USA SQUARE SUBDIVISION

APPLICATION NUMBER 13 DATE June 19, 2008
APPLICANT USA Square Subdivision
REQUEST Subdivision

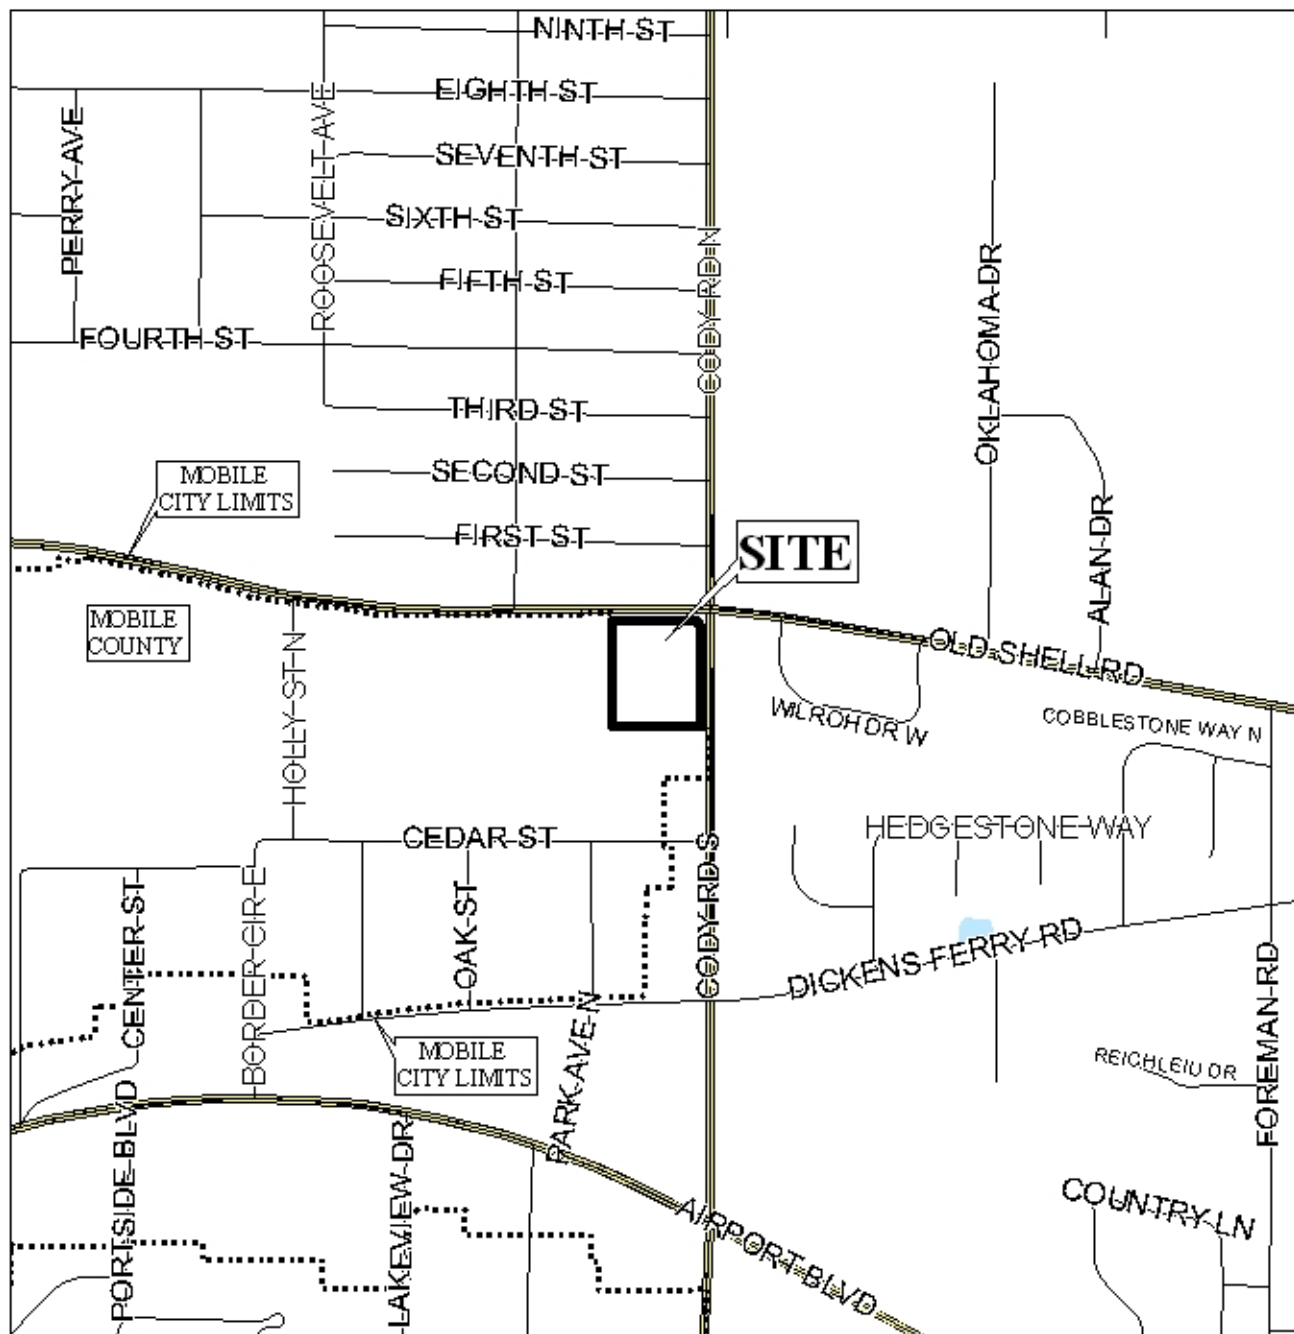
The plat should be revised to label each lot with its size in square feet.

- 5) The labeling of the lots with their size in square feet;
- 6) Submission of 7 copies of final Berdie Broadus Subdivision plat prior to the signing of the USA Square Subdivision plat; and

DETAIL SITE PLAN

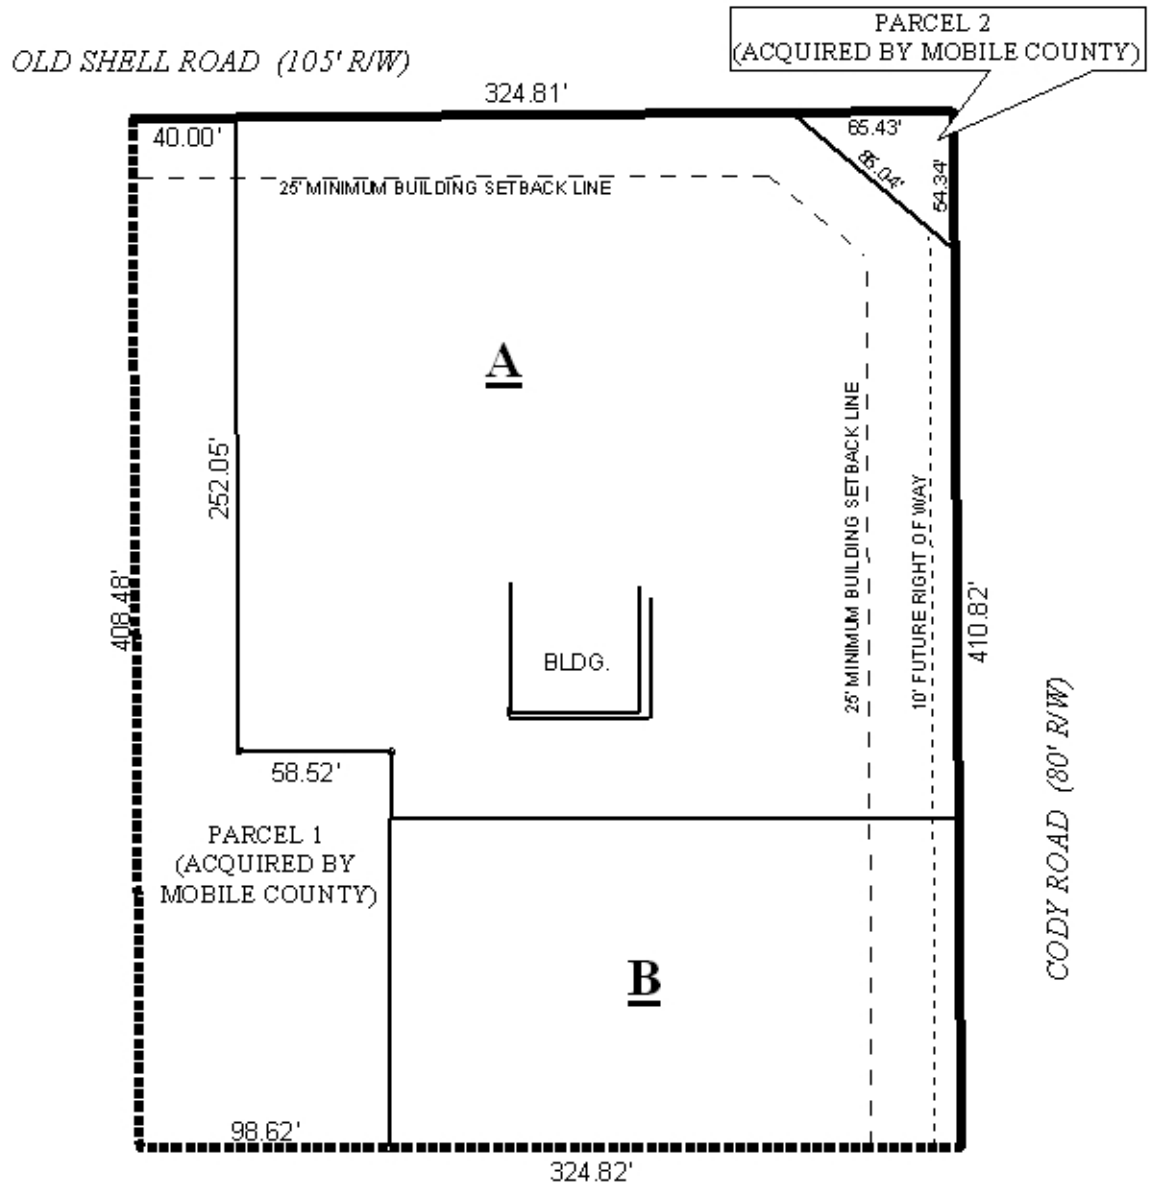
The site fronts onto Old Shell Road and Cody Road, both proposed major streets. The right-of-way for Old Shell Road meets the minimum width requirements, however the right-of-way for Cody Road is only 80 feet in width, which is less than the 100-foot width required by the Major Street Plan component of the Comprehensive Plan. Additional right-of-way along Cody Road should be dedicated to provide 50-feet of width, as measured from the centerline of Cody Road.

Due to the status of Old Shell Road and Cody Road as major streets, proposed Lot A should be limited to its existing curb-cuts (which should be shown on the final plat), and Lot B should be limited to one curb-cut, with the size, design and location of all curb-cuts to be approved by Traffic Engineering and conform to AASHTO standards.

- 1) Dedication of right-of-way along Cody Road sufficient to provide 50-feet as measured from the centerline;
- 2) Depiction of the existing curb-cuts for Lot A, and placement of a note on the final plat stating that Lot A is limited to the existing curb-cuts, and that Lot B is limited to one curb-cut, with the size, design and location to be approved by Traffic Engineering, and to conform with AASHTO standards;
